Access Compliance Report

Public Rights-of-Way

(Curb Ramps)

Intersection ID: 51575	Main Street: THRIFT_RD	Cross Street: RUSHING_CREEK_LN	Location:	N
ADA ID: 77F3B45CF6CF	Ramp Type: Perp	Initial Pass/Fail: Fail	Overall Compliance: No	Severity Score: 21.25
Codes/Mitigation Info/Possible Solution		Field Measurements/Component Compliance

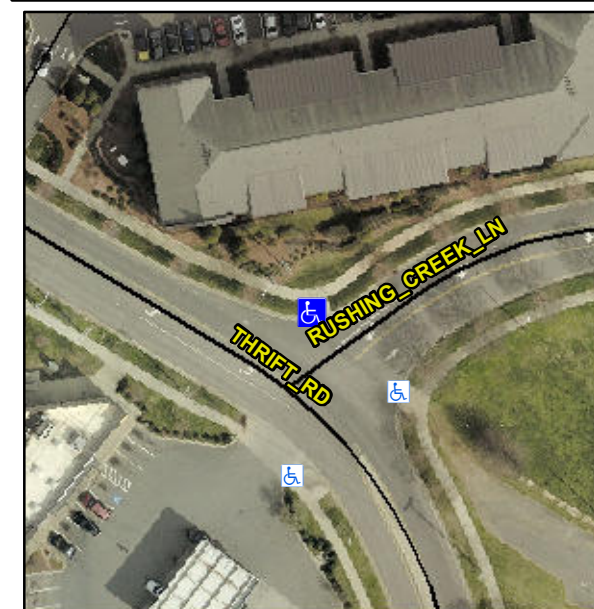
Not Found, R304.5.1, R304.2.2

Compliance	Description	Data	Compliance	Description	Data
N/A	Ramp Length (in)	96.0	No	Ramp Slope (%)	8.7
No	Ramp Width (in)	47.0	Yes	Ramp XSlope (%)	0.1
N/A	Flare Type LT	N/A	N/A	Flare Type RT	N/A
N/A	Flare Slope LT (%)	N/A	N/A	Flare Slope RT (%)	N/A
N/A	Flare Traversable LT?	N/A	N/A	Flare Traversable RT?	N/A
N/A	Landing Length (in)	N/A	N/A	DWS Provided?	N/A
N/A	Landing Width (in)	N/A	N/A	DWS Contrast?	N/A
N/A	Landing Slope (%)	N/A	N/A	DWS Length (in)	N/A
N/A	Landing X Slope (%)	N/A	N/A	DWS Full Width?	N/A
N/A	Landing Curb? (Y/N)	N/A	N/A	DWS Offset (in)	N/A
N/A	Shared Landing?	N/A			
N/A	Gutter Ponding?	N/A	N/A	Gutter Slope (%)	N/A
N/A	Gutter Lip Ht (in)	N/A	N/A	Gutter X Slope (%)	N/A
N/A	Painted X Walk1?	No	N/A	Painted X Walk2?	N/A
	X Walk 1 Direction	To SE		X Walk 2 Direction	N/A
N/A	X Walk 1 Width (in)	N/A	N/A	X Walk 2 Width (in)	N/A
	X Walk 1 Slope (%)	4.2		X Walk 2 Slope (%)	N/A
	X Walk 1 X Slope (%)	1.6		X Walk 2 X Slope (%)	N/A

Remove & Replace Entire Ramp.
